Technical Service Bulletin

SUBJECT:			No: TSB-22-16-002
ENGINE CRANK / NO START IN EXTREME COLD – DTC P062D			DATE: March 2022
			MODEL: 2022 Outlander
CIRCULATE TO:	<input type="checkbox"/> GENERAL MANAGER	<input checked="" type="checkbox"/> PARTS MANAGER	<input checked="" type="checkbox"/> TECHNICIAN
<input checked="" type="checkbox"/> SERVICE ADVISOR	<input checked="" type="checkbox"/> SERVICE MANAGER	<input checked="" type="checkbox"/> WARRANTY PROCESSOR	<input type="checkbox"/> SALES MANAGER

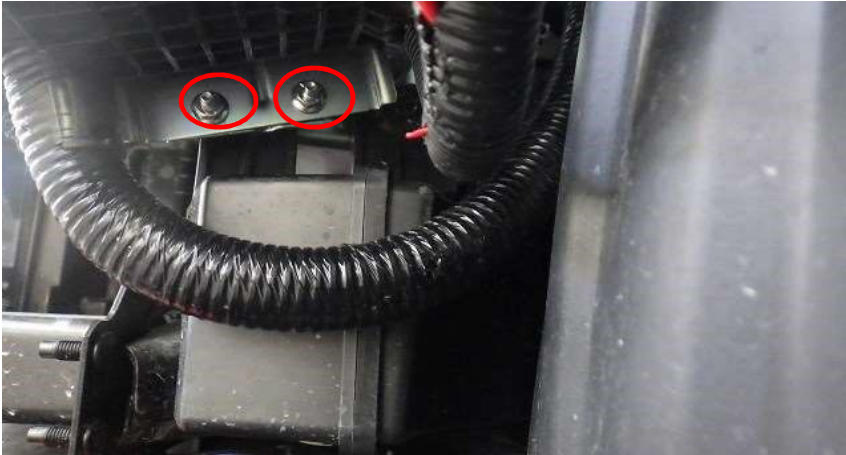
- Remove the relay box cover.
- Turn IG-OFF and replace the 4 relays indicated below (INJ, ST CUT, SR MTR x 2).

PART NAME	PART NUMBER	QUANTITY	REMARKS
RELAY, POWER (MICRO ISO)	8627A049	4	INJ, ST CUT, SR MTR x2
